# Parker Water and Sanitation District

RE: Comments on the Draft Phase I Colorado River Water Availability Study Report

## LYTLE WATER SOLUTIONS, LLC

Subject: Comments on the Draft Phase I Colorado River Water Availability Study Report.

<b>PARKER WATER AND SANITATION DISTRICT</b>	
<b>CLIMATE MODEL GRID AND DRAINAGE BASIN COMPARISON</b>	
File Name: ClimateModel@Grid.cdr	Date: 05/10/2010
Project No.: 1203-10	Drawn By: VAL Fig. No.: 1

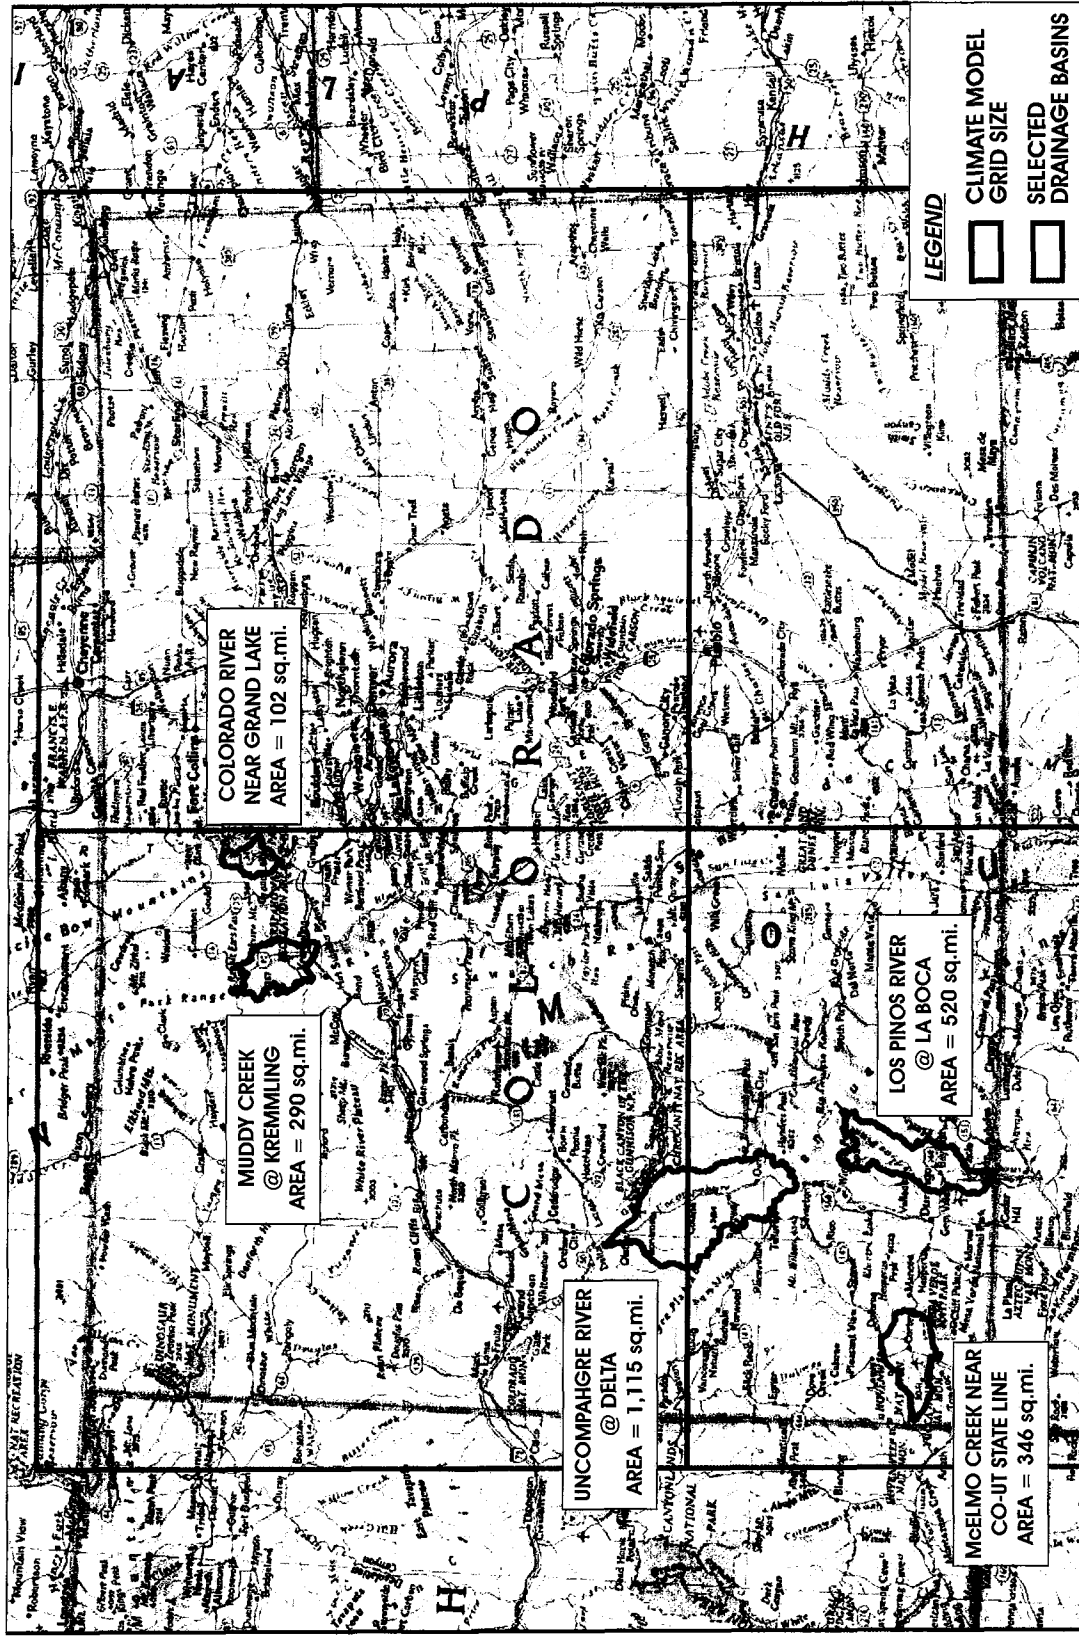
Initially, we have serious concerns with the scientific validity of GCMs in general. One issue that is not discussed in the draft Study report is whether these GCMs have been calibrated to existing conditions. Typically, future predictive models are calibrated based on historical data to see if the models can replicate the historical data. Without such calibration, these models cannot initially be used as any reliable predictor of future conditions. Beyond such calibration, with the grid discretization of these GCMs, only one temperature and precipitation value can be obtained for each time step in the model per cell. Therefore, the values obtained from any GCM is averaged over the grid size. As acknowledged in the draft Study report, this coarse resolution means that temperature and precipitation data may be averaged over an area extending from the Continental Divide to Cortez, or from the Continental Divide to the Dinosaur National Monument, both very different climatic regions which would be averaged in one cell of the GCMs.

Regardless of the resolution of the GCMs, the draft Study report presents estimated flows at gages in drainage basins considerably smaller than 40,000 square miles, as shown in Table 1. The largest drainage area where flows were simulated is 8,050 square miles (Colorado River near Cameo), which requires the GCM results to be extrapolated and adjusted approximately 5 times from the model resolution, while the smallest drainage area hydrograph is 102 square miles (Colorado River near Grand Lake), which would require an extrapolation in resolution of 392 times from the GCM results. Since the GCM model results cannot provide this resolution, estimates of flow made by the Study team are not based on, nor can be justified by, use of the GCMs. To illustrate, Figure 1 shows the size of the CGM grid and some of the drainage areas where future flow characteristics are estimated in the study report (Table 1). These estimates cannot be made from the GCMs.

- (3) How can GCM output data that produces one value for each time step over a 40,000 square-mile area (cell size) be used to predict flows in basins as small as 102 square miles?
